Operation Inspection Report
for
Department of Energy

Date of Inspection September 21, 1994

Dam Name Dams A-4, B-5 & C-2

Department of Energy (Facility Name) Rocky Flats

Photo 9. View of Outlet Works of Pond A-4 Dam. Note heavy vegetation.

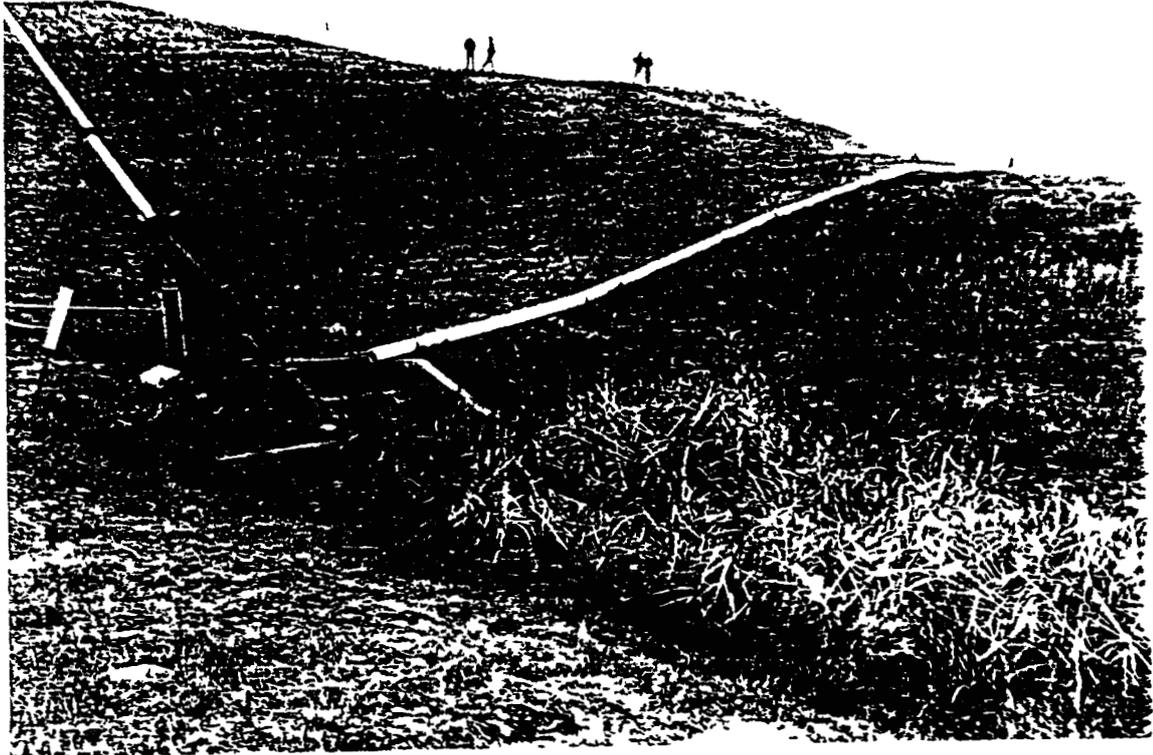
The outlet works consists of an 18-inch (46 cm) reinforced concrete pipe (RCP), which discharges into a concrete stilling basin. Heavy vegetative growth in and around the outlet structure (Photo 9) prevented the observation of any telltale signs of piping around the outlet pipe. The visible portion of the structure, however, appeared in a good condition. No cracks or spalls in the concrete were noted. The outlet works channel also had heavy vegetation growth (Photo 10). The shut-off gate is located at the downstream end of the conduit. This is not a desirable feature since the conduit is continuously pressurized which greatly increases the risk of leakage through pipe joints which could cause piping along the outside of the conduit.

(1) Heavy vegetation growth in the outlet structure area prevents proper inspection for piping along the outlet pile. This as well as vegetation on the upstream face near the crest level should be cut back.

(3) It is recommended that the existing outlet gate be operated on an annual basis. Also an outlet works gate should be installed on the upstream side of the outlet works to reduce risk of piping along the outside of the conduit.

Photo 25. View of Remote Telemetry System at Pond C-2 crest

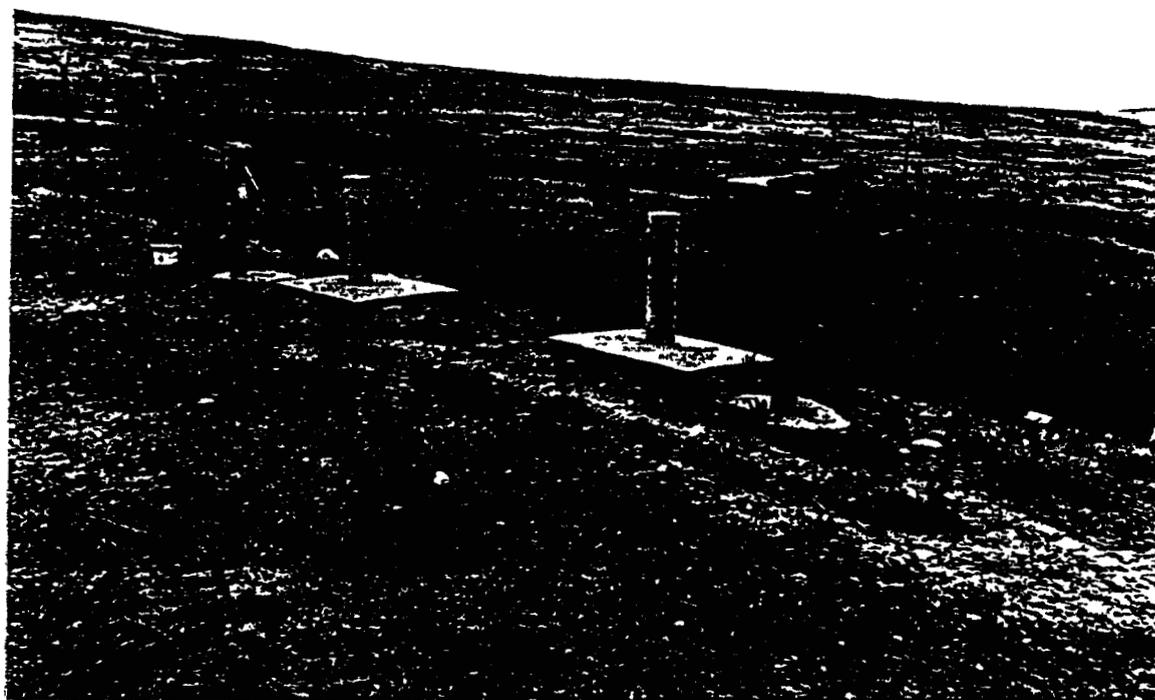
Dam C-2 Five additional piezometers were installed during June, 1994. Two of them, C2-94-02 and C2-94-03 are at the crest and the other three, C2-94-11, C2-94-12a, and C2-94-13a are at the toe of the dam. A view of the telemetry system at C-2 is seen in photo 25. The readings for these piezometers appear to be following the reservoir level in the dam, though more data will be required to arrive at any conclusions.

1994 Elevations of Pond A-4 and Piezometers

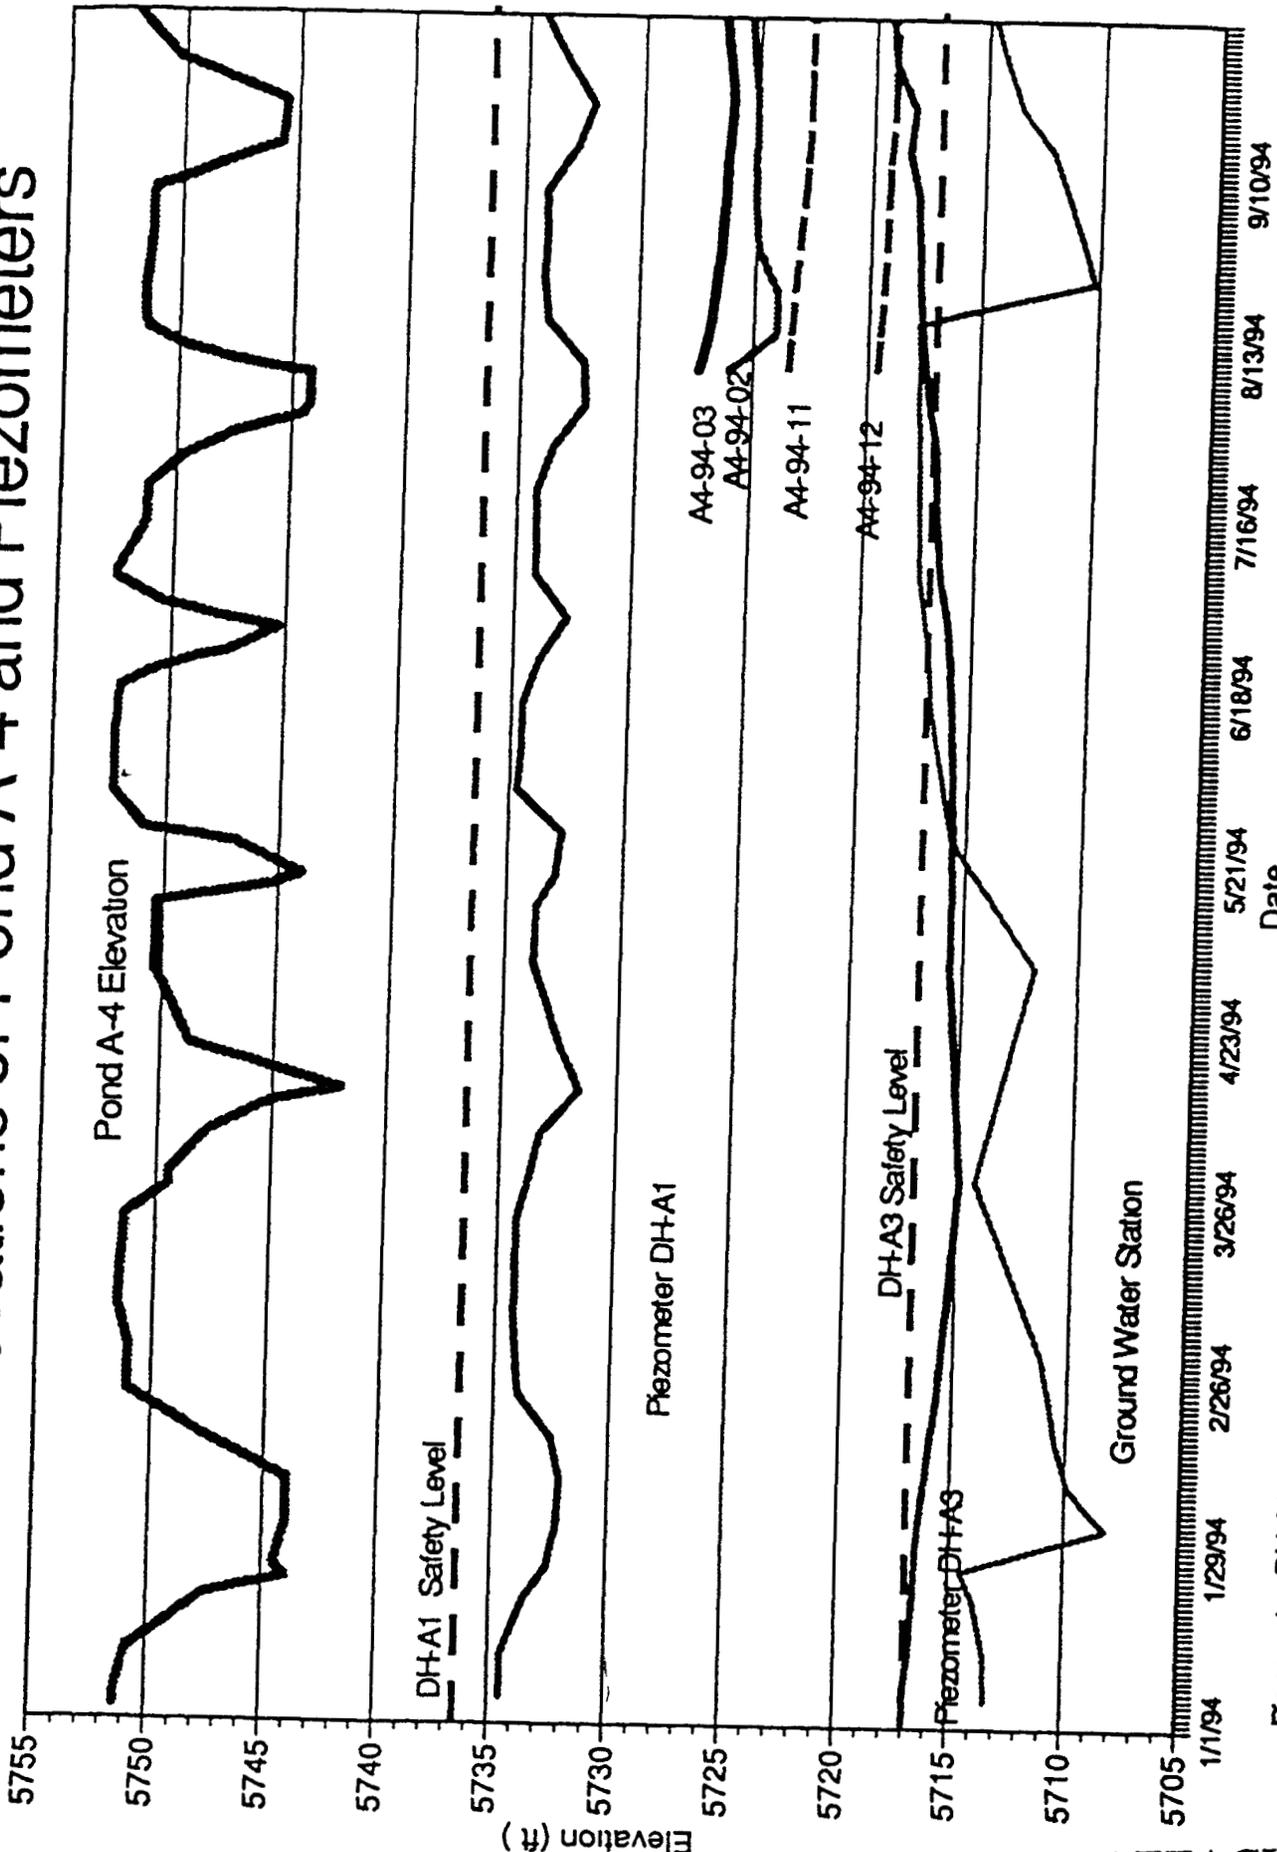
Dam A-4 Four new piezometers were installed in July, 1994. Two of these, A4-94-02 and A4-94-03 are at the crest and the other two, A4-94-11 and A4-94-12 are at the toe of the dam. Enough data from these four piezometers have not been collected to indicate any definite correlation with the pond level. In fact, during the period of 8/8/94 to 8/15/94, the reservoir level rose by 7 feet, but the piezometer readings did not respond. Actually, for A4-94-03, it went down by a couple of feet. We shall need to have more data before any conclusions can be drawn. Perhaps the instruments also need to be checked to see if these are functioning properly.

The reservoir levels indicate that the reservoir was being operated at substantially higher capacity and over a longer period of time during the data period than originally intended. The highest elevation has been as high as 54% full.

1994 Elevations of Pond B-5 and Crest Piezometers

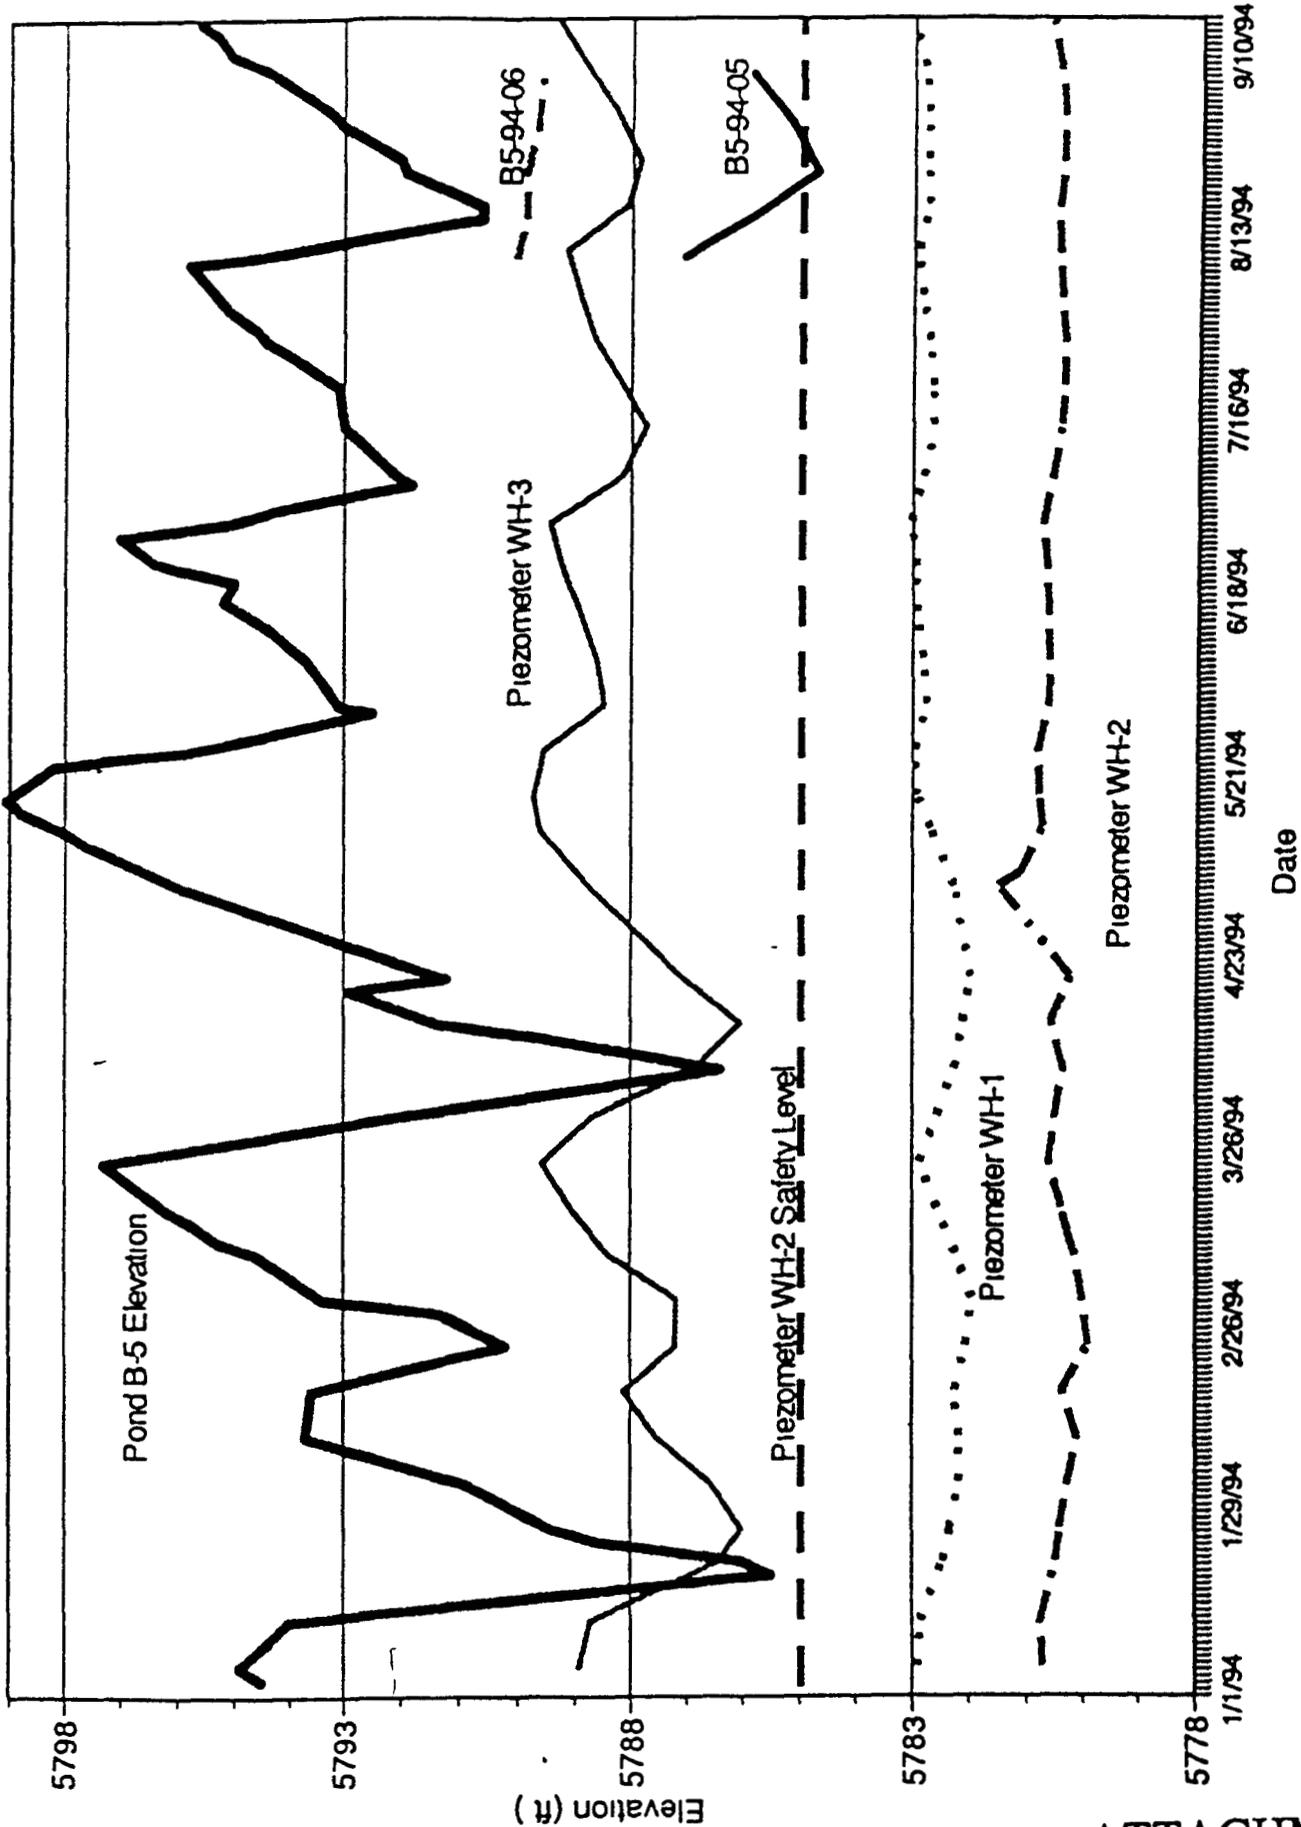
Dam B-5 Three new piezometers were installed in June, 1994. Two of these, B5-94-05 and B5-94-06 are at the crest and the third, B5-94-11 is at the toe of the dam. See Photo 24 for installed piezometers, inclinometers, and remote telemetry system. As for Dam A-4, very little data are available for these piezometers, to arrive at any conclusions. Readings for B5-94-06 appear to be going down as the pond level goes up. Pressure readings for B5-94-05 appear to follow the pond level variation.

As for Dam A-4, the reservoir levels indicate that the reservoir was being operated at higher capacity than originally intended. The highest elevation has been as high as 60% full.
